Strathfield Internal Development Assessment Panel Meeting

Friday, 11 October 2019

SUBJECT: DA2017/125/01- 36 HUNTER STREET, STRATHFIELD
LOT 64 DP 7837

Proposal: Section 4.55(2) application to amend the internal layout and location of external windows.

Figure 7: First floor plan

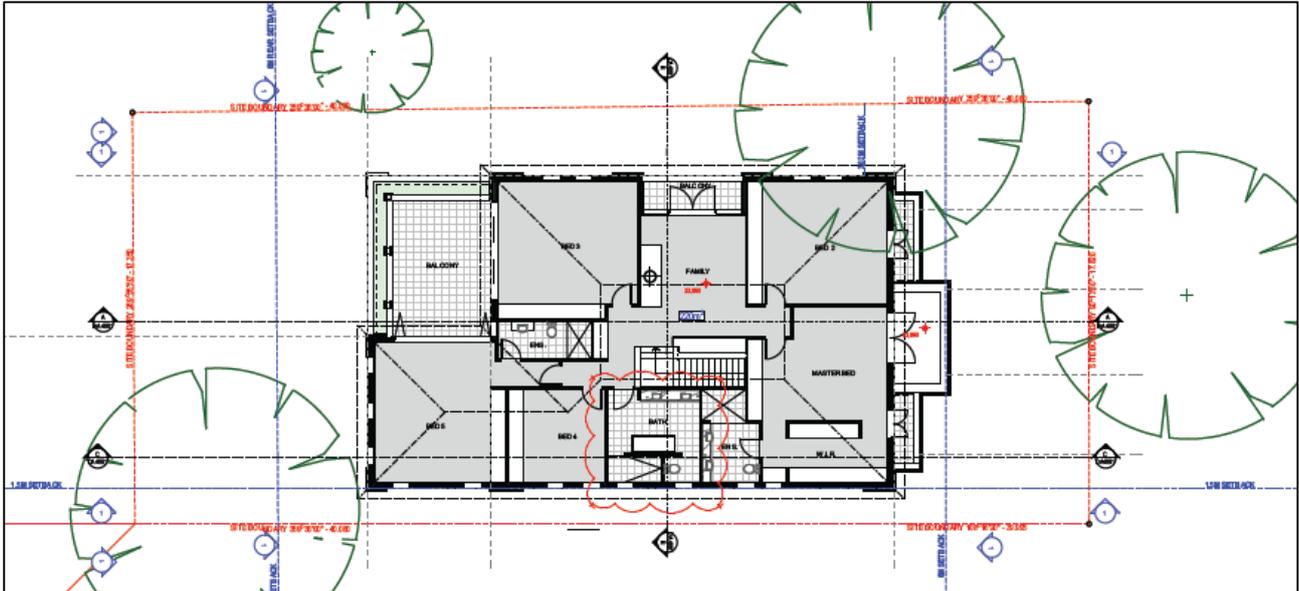
The length and depth of the first floor rear balcony depicted on the First Floor Plan, Drawing No. DA-203, Rev C is to be reduced to a depth 1m by 2m width so as to comply with Section 14.3.4 of Part A of the SCDCP 2005. Amended plans demonstrating compliance with the above shall be submitted and approved by the Principal Certifying Authority prior to the issue of a Construction Certificate.

Figure 8: Originally approved eastern elevation.

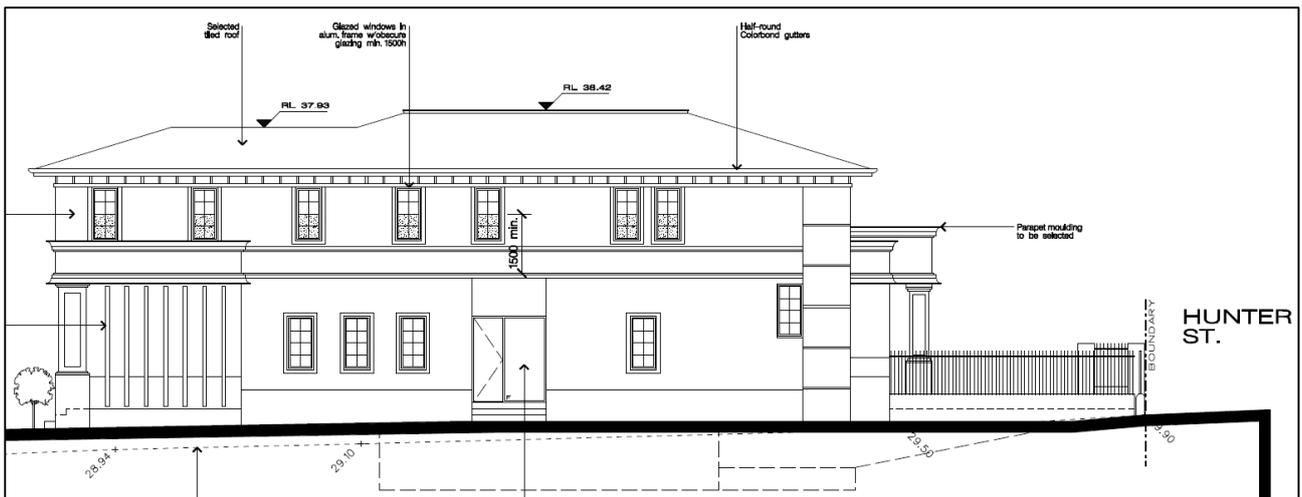
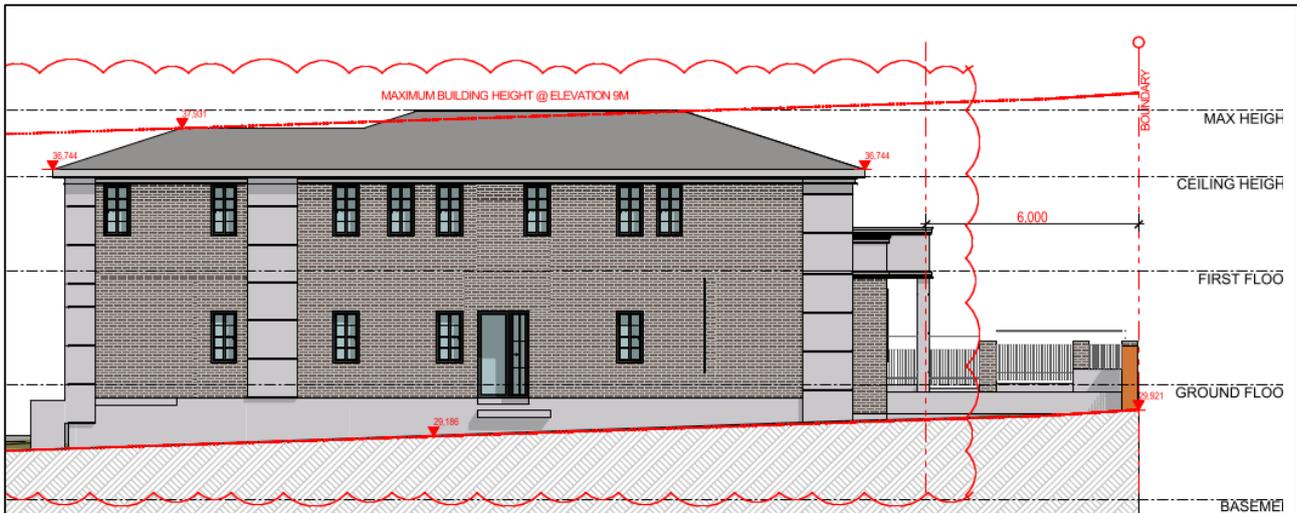
Comments: The proposed substitution of the rendered masonry with the exposed facebrick 'Black Beauty' to the dwelling façade creates visual interest by providing a contrasting colour against the 'dulux white' columns. The amended colours and external finishes scheme is compatible with the surrounding streetscape featuring a mix of rendered masonry and exposed facebrick finishes dwellings. The modification proposes to remove the horizontal rendered masonry banding along the eastern elevation (Figures 8 and 9). The removal of the banding is not supported as the architecture feature provides articulation and visual relief to an otherwise 14.25m unbroken wall. As such a condition of consent has been recommended for the horizontal banding to be retained from the original approved design.

The entire length of the eastern elevation shall have a horizontal rendered masonry banding positioned between the ground level and first floor as depicted in the original development consent (DA2017/125). Amended plans demonstrating compliance with the above shall be submitted and approved by the Principal Certifying Authority prior to the issue of Construction Certificate.
